MINUTES/ACTION LIST

Sub-Contractor Meeting – CP interiors (Brise Soleil)

Project: Makai, La Route de la Baie, St Brelade

BRISE SOLEIL - Blades

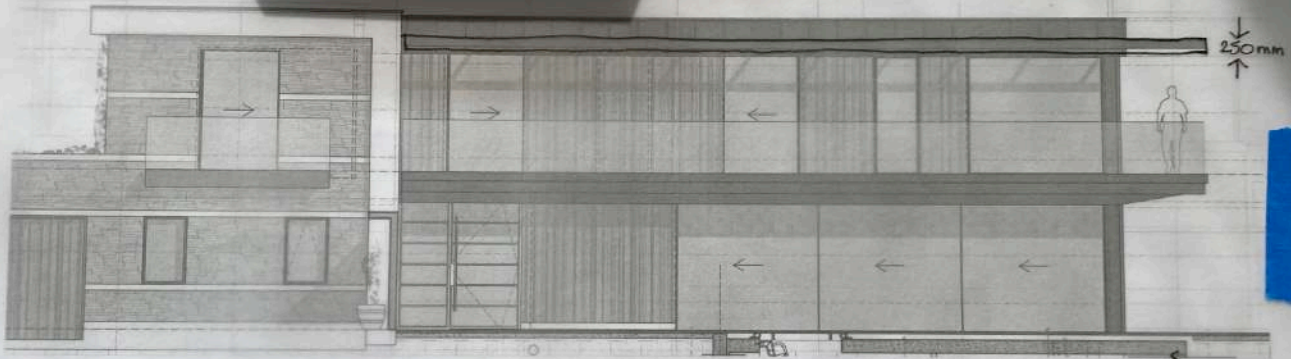
Photos of the Renson Icarus Blade samples attached. CR basing designs upon the following:

- Approx 200mm wide blades.
- 7 blades to be used for the South-facing screen. 1,560mm wide approx.
- 5 blades to be used for the West-facing screen. 1,150mm wide approx.
- Blades ideally to be 'wrapped' with a light oak finish. ACW to check whether this is available and whether the finish is suitable for a maritime setting. **ACW**
- All other bracketry to be powder coated for a maritime specification.
- Blades ideally to be suspended from outrigger brackets to lower them down from the fixing point within the RC ring beam.
- Ideally, CR would prefer a nominal 250mm deep fascia to contain the blades – powder coated.
- The Renson quote should be supply and fix and should supply all material from the thermally broken primary bracket (to be supplied by others) onwards.
- ACW to review quotation. **ACW**
